Subject: Transmittal of Class 1 Permit Modification Request to Remove a Refrigeration Unit from Technical Area 54, Pad 11, Dome 375

**Class 1 Permit Modification Request to
Remove a Refrigeration Unit from
Technical Area 54, Pad 11, Dome 375**

Document: Class 1 Modification to Remove TA-54, Pad 11, Dome
375 Refrigeration Unit
Date: January 2018

Figure G.12-1: Technical Area 54, Area G, Pad 11 Outdoor Container Storage Unit Grid Sampling and Additional Sampling Locations

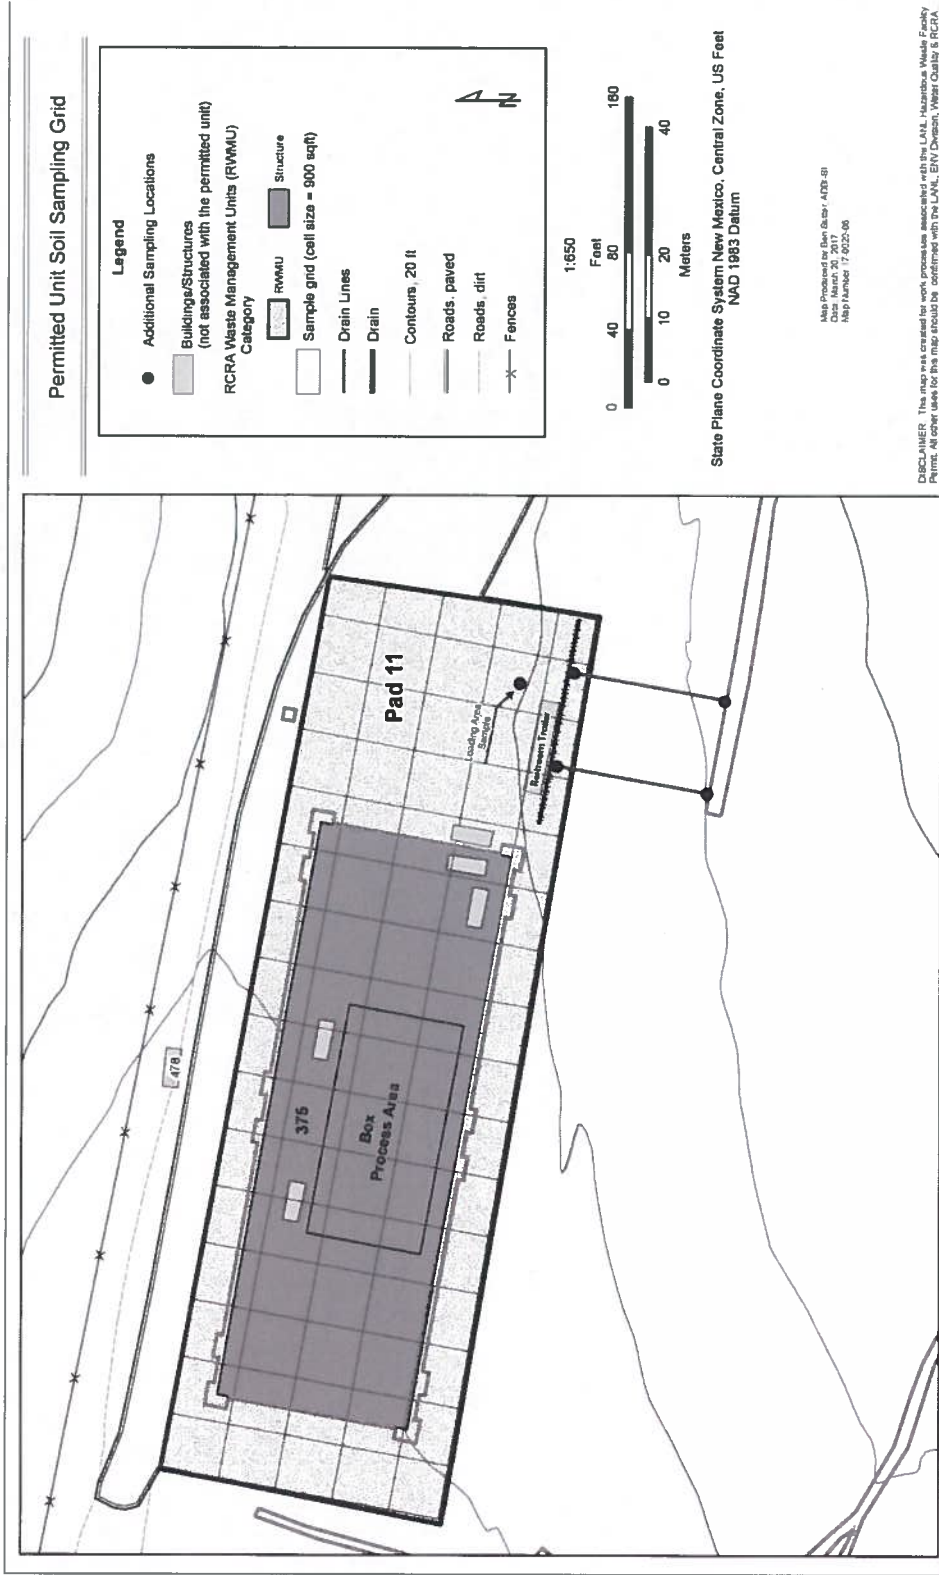
Proposed changes to the closure plan include changing the description of the refrigeration unit within Section 2.0, *Description of Unit to be Closed*, to past tense. Additionally, the refrigeration unit footprint has been removed from Figure G.12-1: *Technical Area 54, Area G, Pad 11 Outdoor Container Storage Unit Sampling Grid and Additional Sampling Locations*.

Figure 36: TA-54, Area G, Pad 11

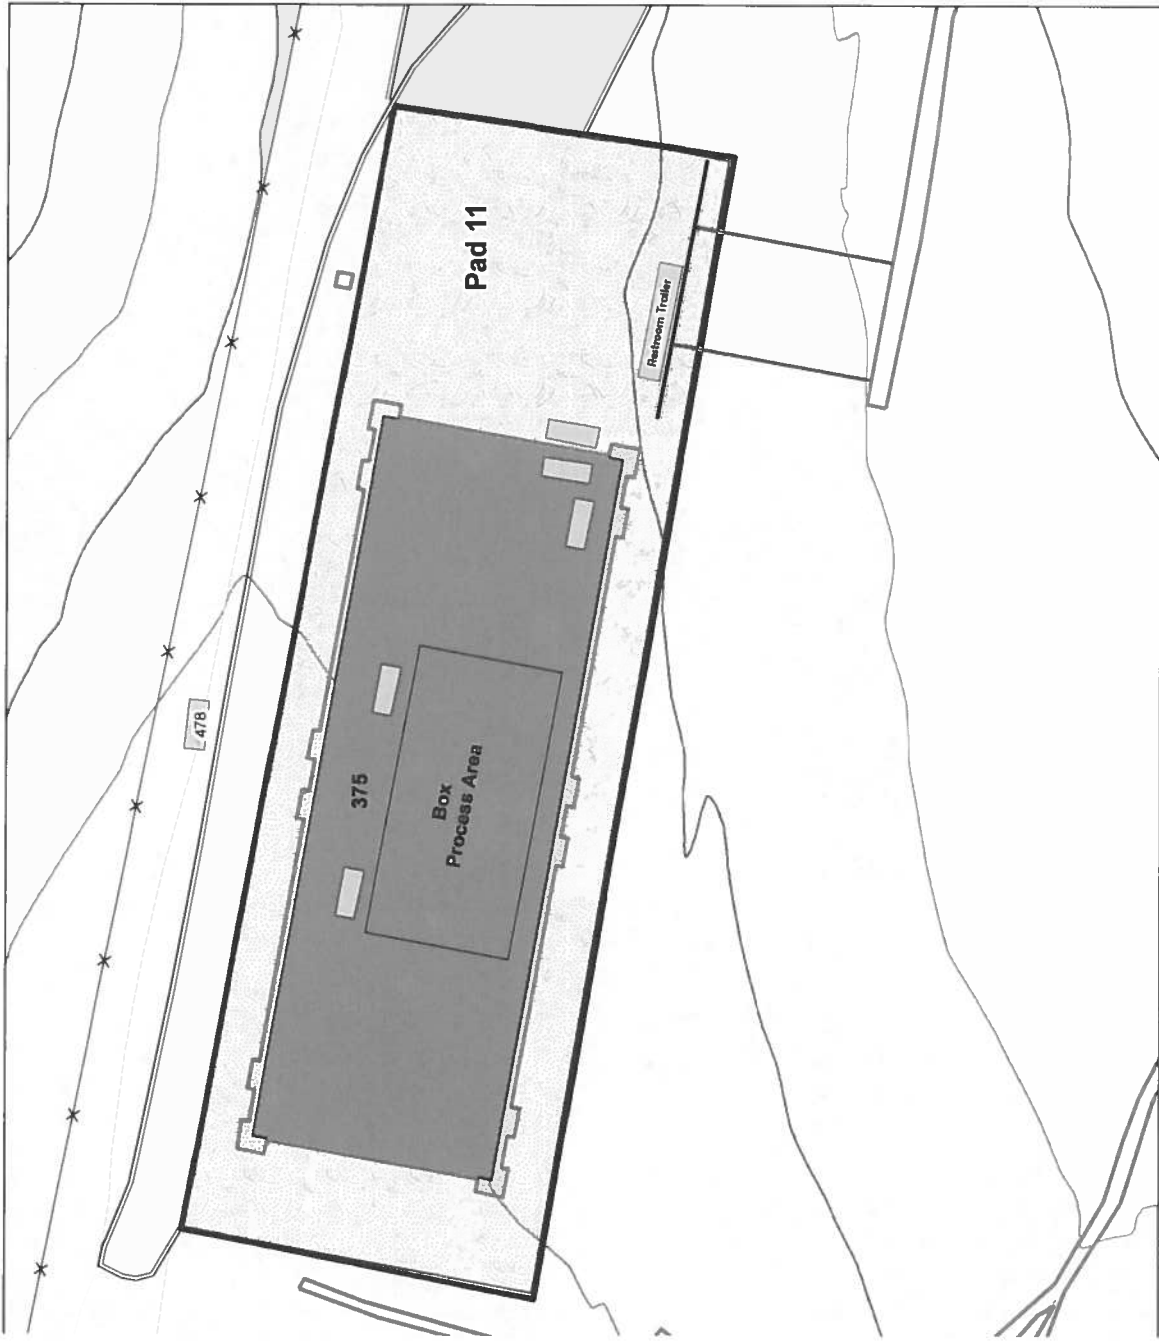
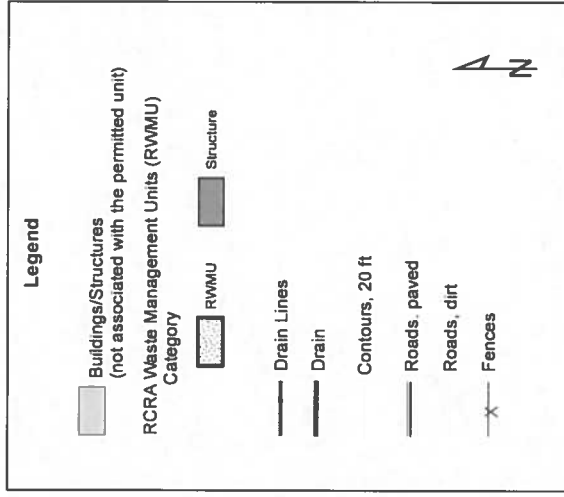
Figure 36: Technical Area (TA)-54, Area G, Pad 11 was revised to reflect the removal of the refrigeration unit.
